**Town of Duanesburg  
Planning Board Agenda  
October 20<sup>th</sup>, 2022**

**#22-10 Kagas, Spiro:** SBL# 53.00-1-29.21, (C-1) located at 9938 Western Turnpike is seeking an amendment to add an additional bay to the Ultimate Wishy Wash under section

In response to the comments (*in italics*) of Doug Cole of Prime AE of September 14, 2022, we respond as follows (**in bold**):

SHEET 3 OF 3

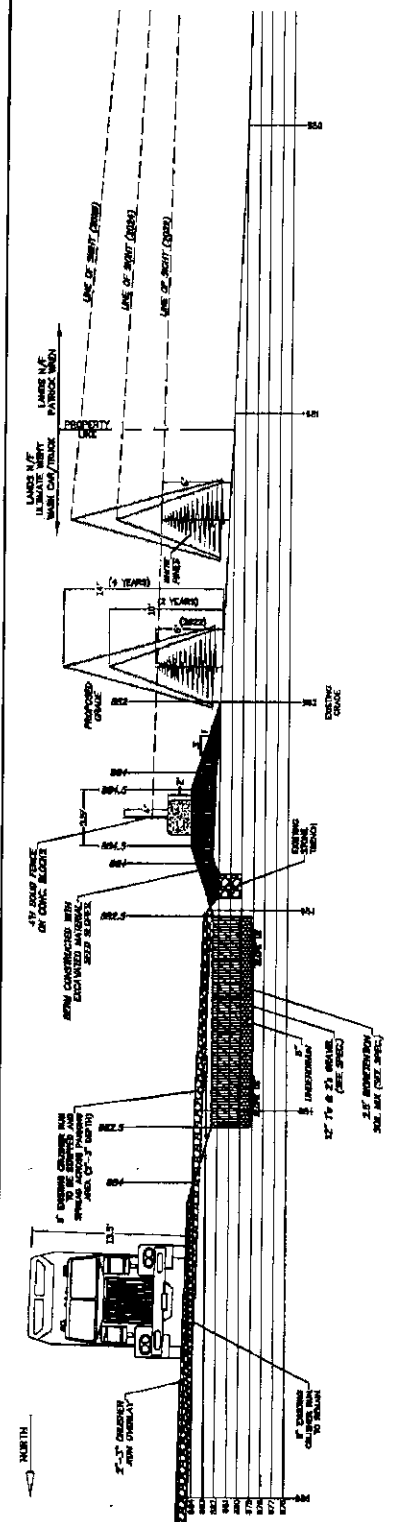
6. On the Site Details Sheet 3/3, the cross section shows a proposed 4-foot solid fence on 2-foot concrete blocks, screened by white pines. This appears to meet the Town Zoning Ordinance maximum fence height of 6 feet. We ask the Applicant to provide the design and materials for the solid fence to confirm that it is compatible with the general surroundings.

- e. Provide ponding depths in addition to elevations for 1, 10 and 100 year storm events on the Bioretention Detail.

**See detail on Sheet 3 of 3.**

**LANDSCAPE PLAN**

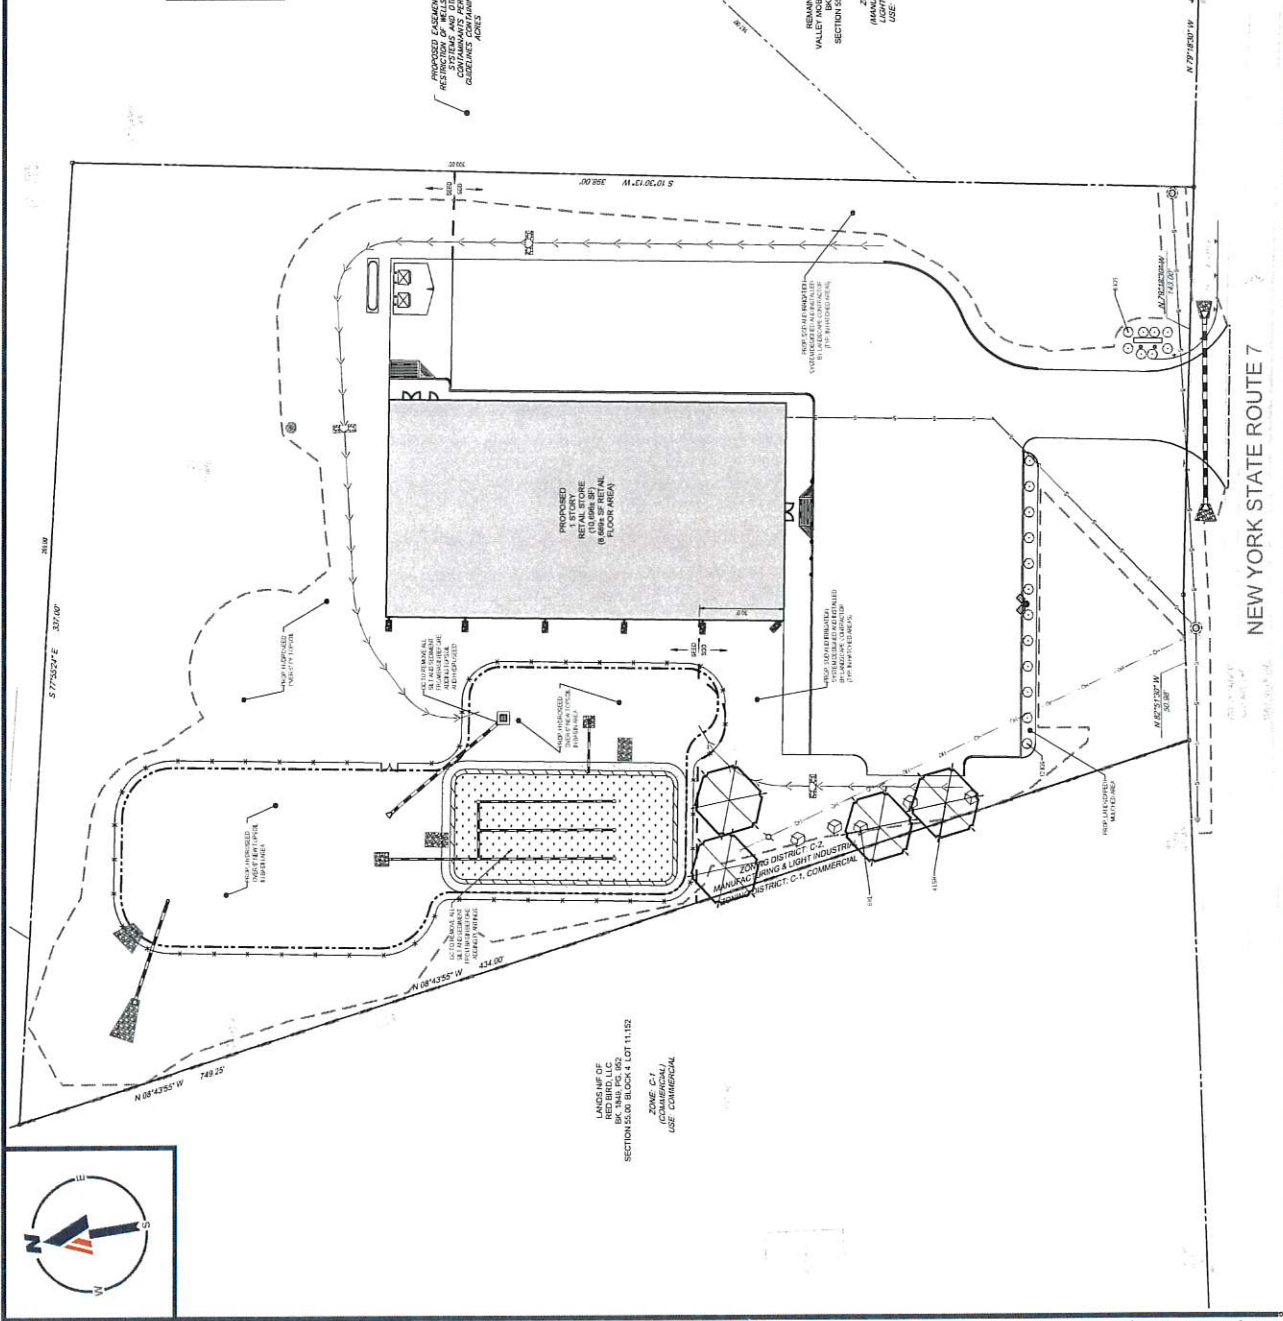
**Comment 3:** "Landscape Plan", Sheet C-701- Include table of bioretention plantings on this sheet or on the "Detail Sheet", C-904.

Comment 3: "Landscape Plan", sheet C-701 – Include table of bioretention plantings on this sheet or on the "Detail Sheet", C-904.

SOIL EROSION & SEDIMENT CONTROL PLAN

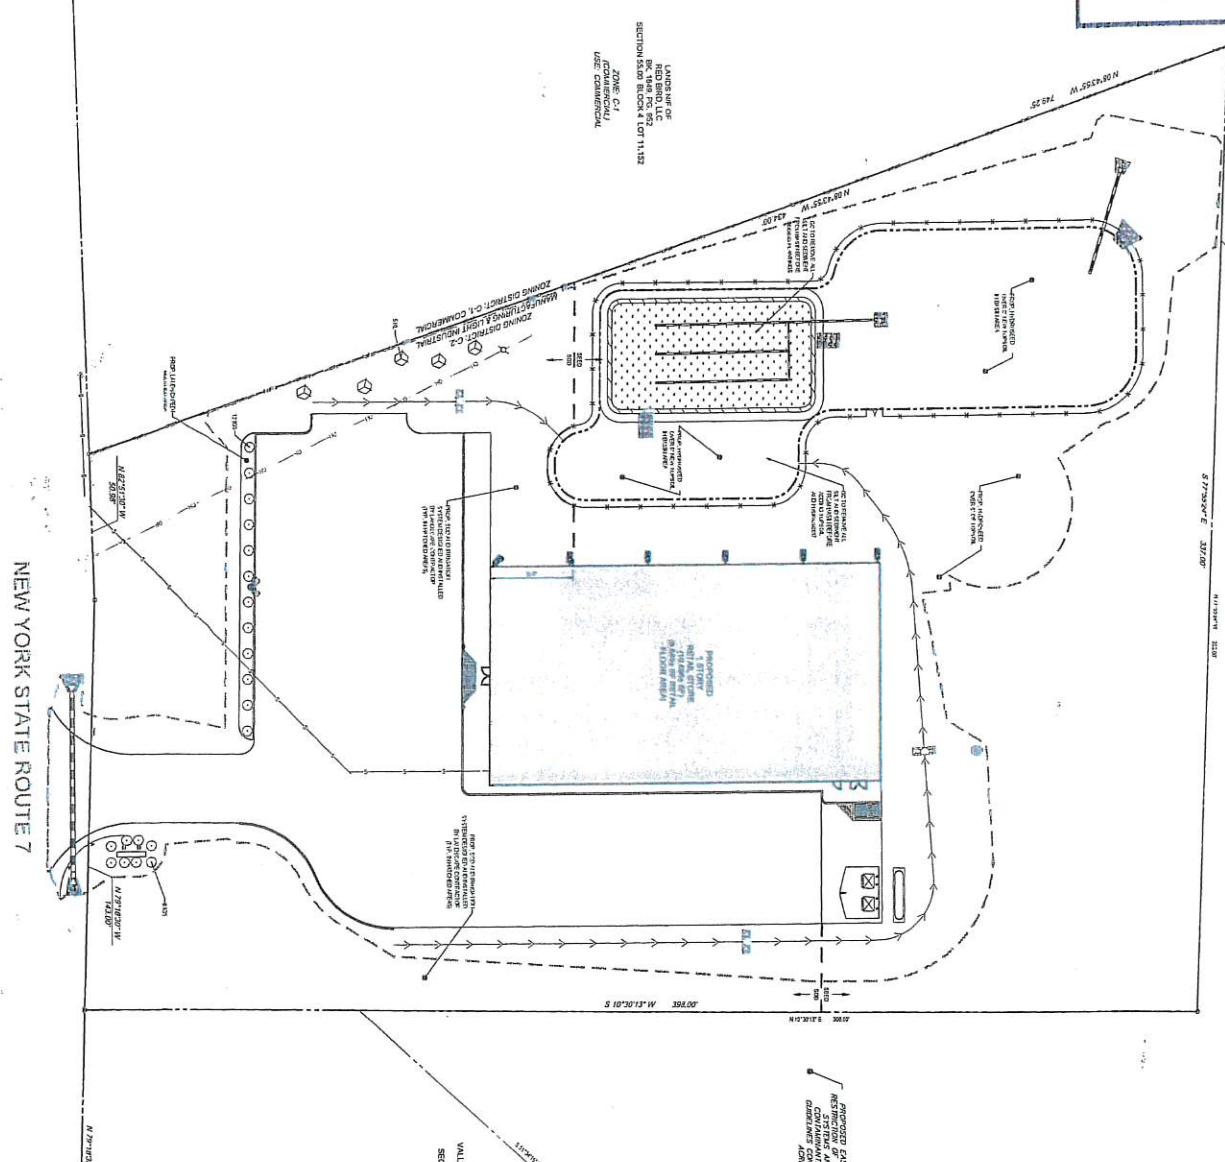
**Comment 2:** "Soil Erosion & Sediment Control Plan", Sheet C-601- Label Sediment Trap location and specify outlet device. It appears as if it is currently labeled "Temporary Settling Basin."

**Comment 2:** "Soil Erosion & Sediment Control Plan", Sheet C-601- Label Sediment Trap location and specify outlet device. It appears as if it is currently labeled "Temporary Settling Basin".
